Product Change Notification / LIAL-24K0XB344

CCB 4477 Final Notice Implement additional cover tape, carrier tape and plastic reel material supplier for selected Micrel products available in 3L, 5L, 6L and 8L SOT23, 5L and 6L TSOP and 8L SOIC packages at STAR assembly site.

Carrier Tape for SOT23-3/5/6/8L , TSOT-5L/6L

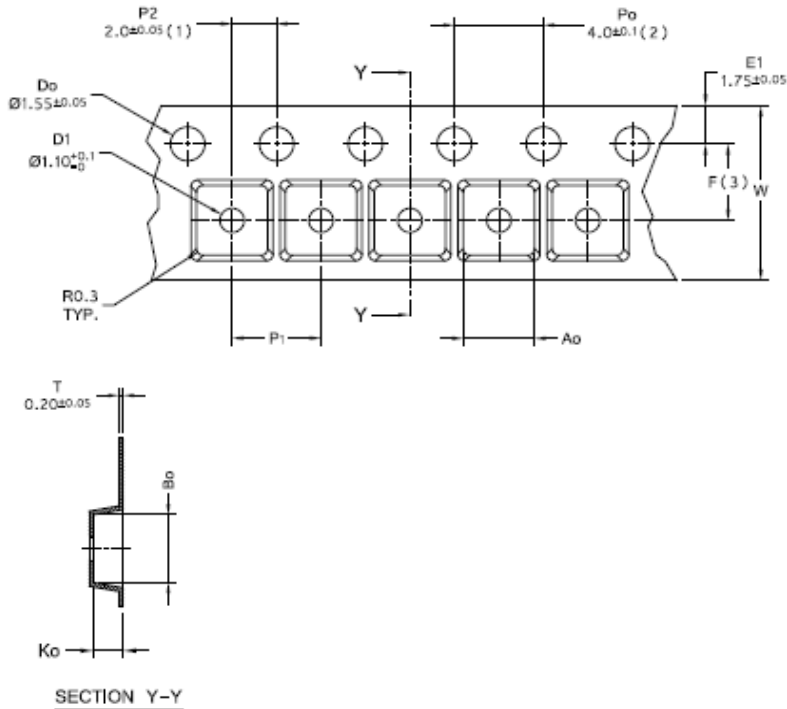
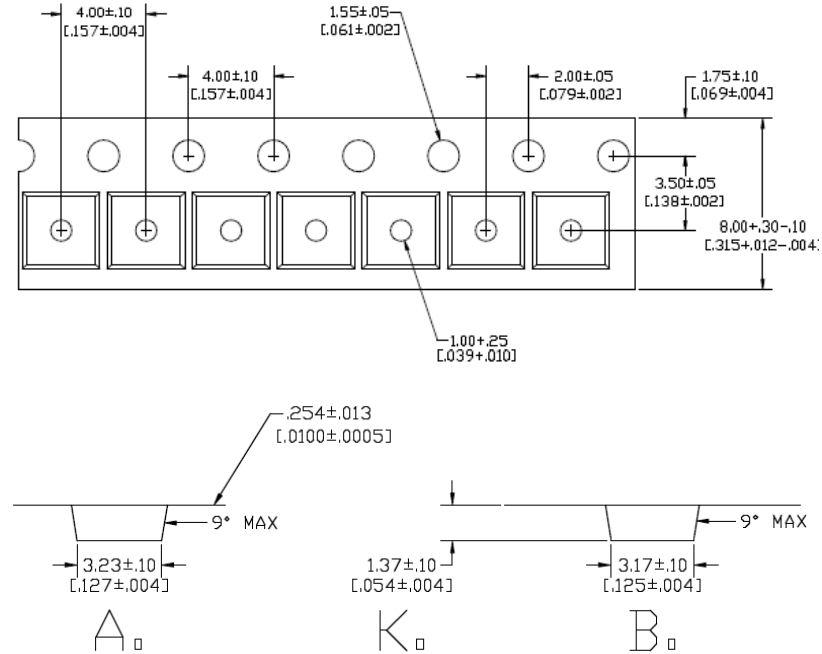
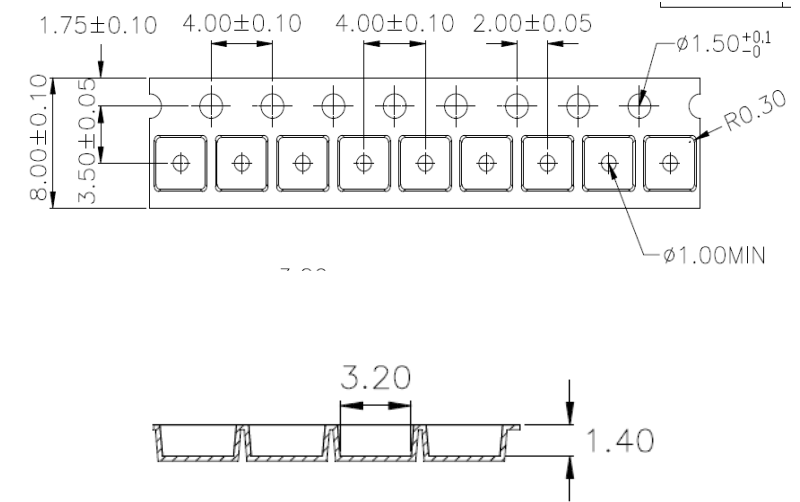
Carrier Tape Supplier	Supplier Mfg. part no.	Width (mm)	Pitch (mm)	A0 (mm)	B0 (mm)	K0 (mm)	Thickness (mm)
CPAK	CP197	8.00 ±0.100	4.00 ±0.100	3.20 ±0.10	3.20 ±0.10	1.40 ±0.10	0.20 ±0.05
3M	0A85CARR SOT23	8.00 +0.30/-0.10	4.00 ±0.100	3.23 ±0.10	3.170 ±0.10	1.370 ±0.10	0.254 ±0.013
U-PAK	SMSC323214	8.00 ±0.100	4.00 ±0.100	3.20 ±0.10	3.20 ±0.10	1.40 ±0.10	0.20 ±0.05

Cover Tape for SOT23-3/5/6/8L , TSOT-5L/6L

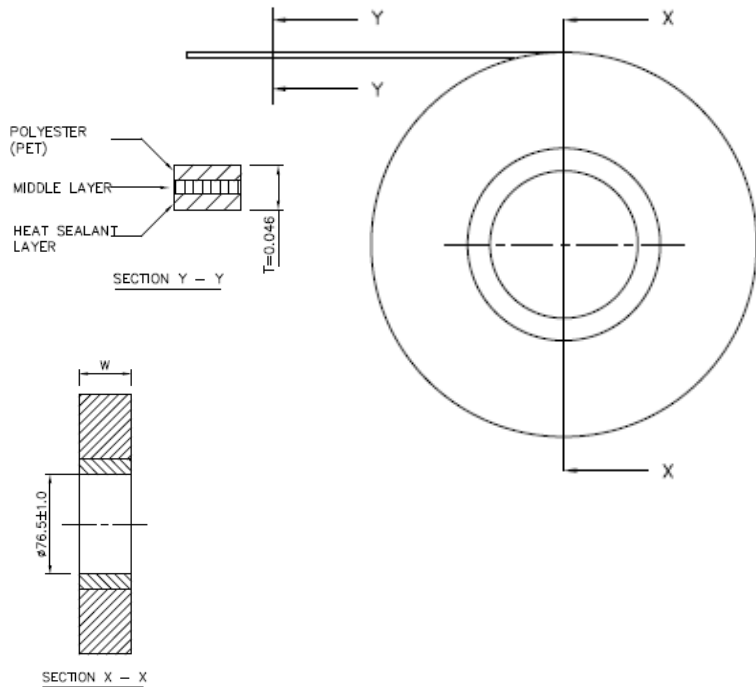
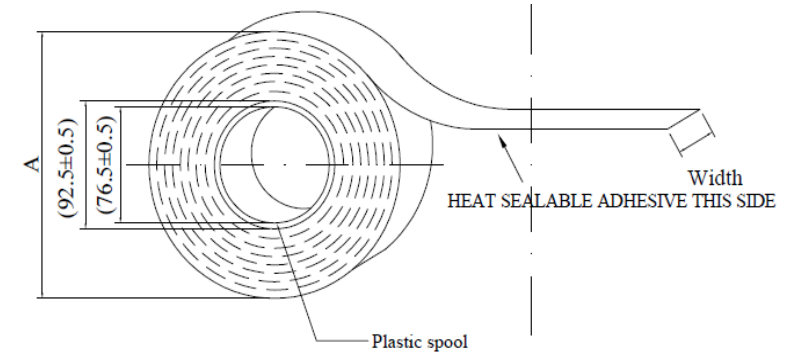
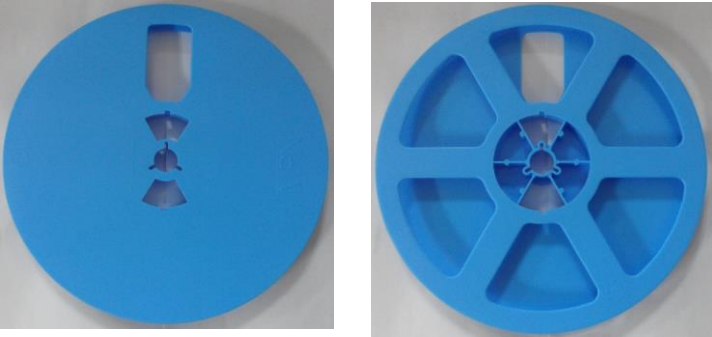
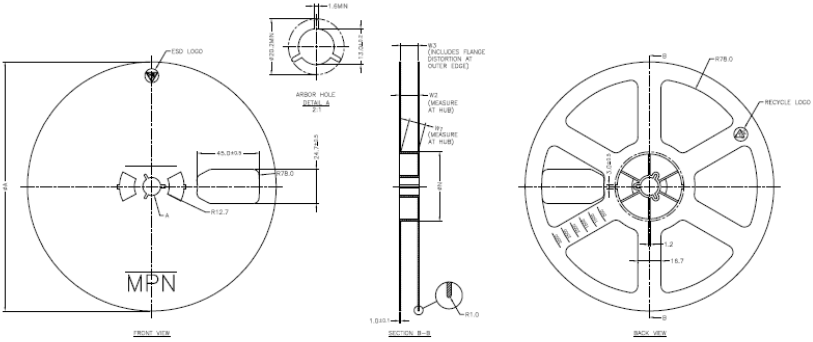
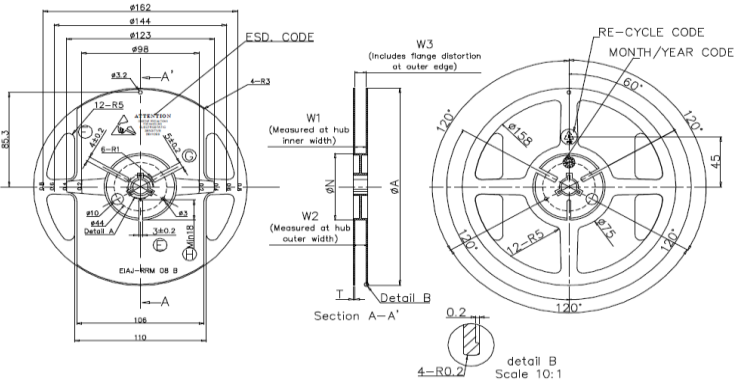
Supplier	Supplier Mfg. part no.	Carrier width (mm)	Cover tape Width "W" (mm)	Thickness (mm)	Sealing Methodology
CPAK	CP38-054A, 5.4 mm	8.4	5.4 ± 0.1 mm	0.046 ± 0.010 mm	Heat Seal
3M	2675, 5.4 mm	8.4	5.4 ± 0.1 mm	0.062 ± 0.013 mm	Heat Seal
U-PAK	UP-175-054	8.4	5.4 ± 0.1 mm	0.048 ± 0.050 mm	Heat Seal

Carrier Tape for SOIC8L

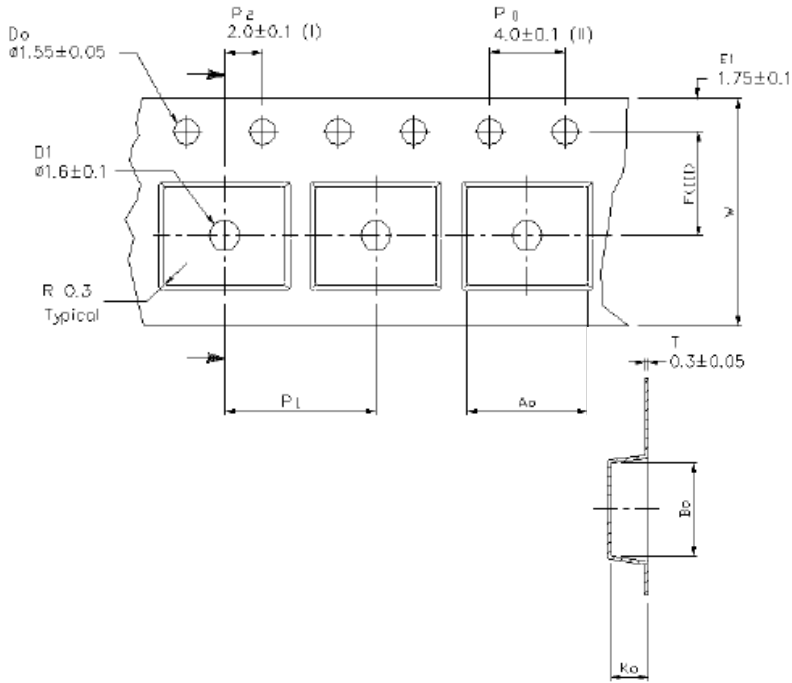
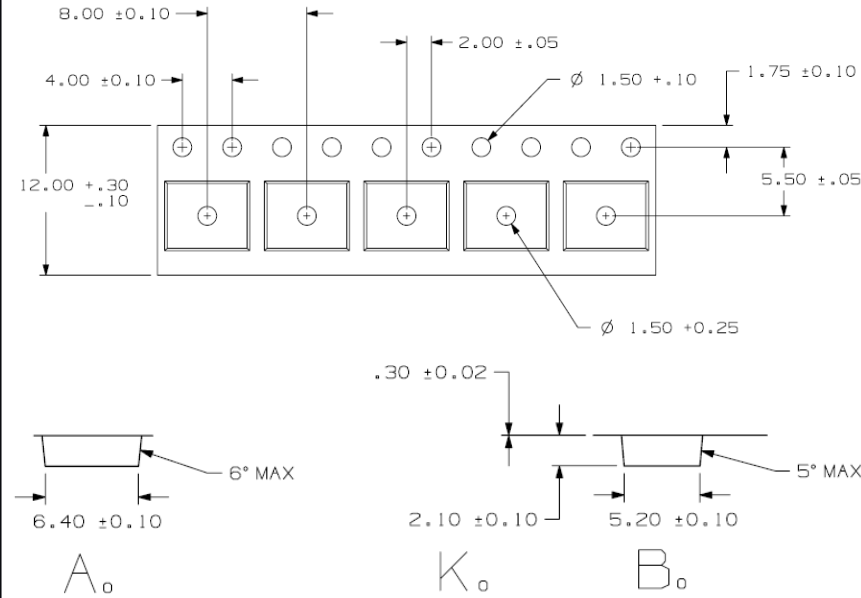
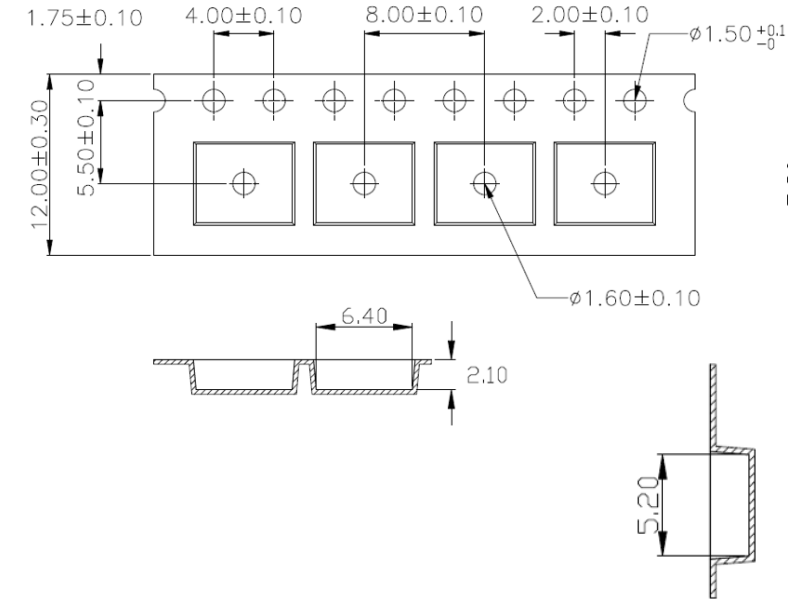
Carrier Tape Supplier	Supplier Mfg. part no.	Width (mm)	Pitch (mm)	A0 (mm)	B0 (mm)	K0 (mm)	Thickness (mm)
CPAK	CPD-092A	12.00 ± 0.100	8.00 ± 0.100	6.40 ± 0.10	5.20 ± 0.10	2.10 ± 0.10	0.30 ± 0.05
3M	TWO13611-4	$12.00 + 0.30 / - 0.10$	8.00 ± 0.100	6.40 ± 0.10	5.20 ± 0.10	2.10 ± 0.10	0.30 ± 0.02
U-PAK	UPKSOIC08A-SMS	12.00 ± 0.100	8.00 ± 0.100	6.40 ± 0.10	5.20 ± 0.10	2.10 ± 0.10	0.30 ± 0.05

Cover Tape for SOIC8L

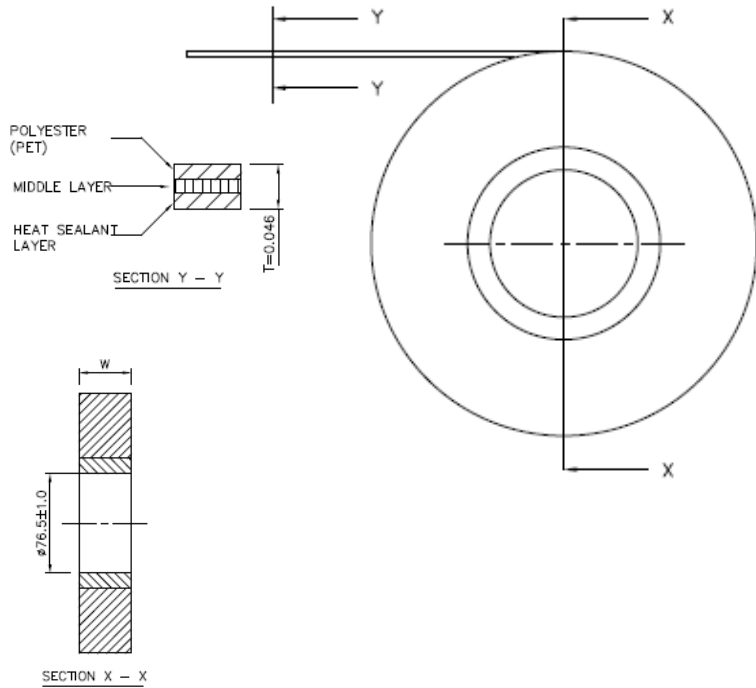
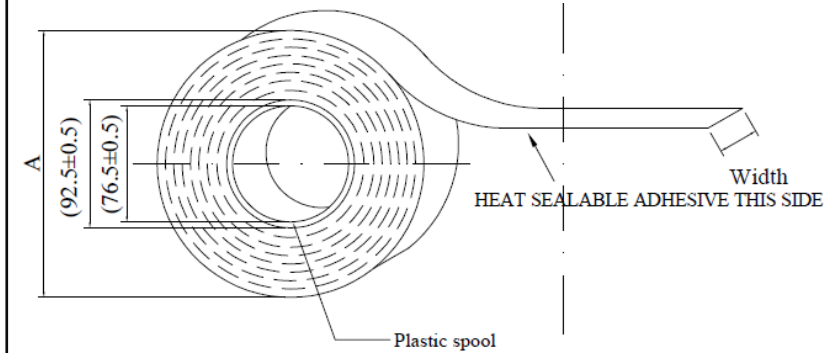
Supplier	Supplier Mfg. part no.	Carrier width (mm)	Cover tape Width "W" (mm)	Thickness (mm)	Sealing Methodology
CPAK	CP38-054A,5.4 mm	12	9.2 ± 0.1 mm	0.056 ± 0.005mm	Heat Seal
3M	2675,9.3 mm	12	9.3 ± 0.1 mm	0.062 ± 0.013mm	Heat Seal
U-PAK	UP-175-093	12	9.3 ± 0.1 mm	0.048 ± 0.050mm	Heat Seal
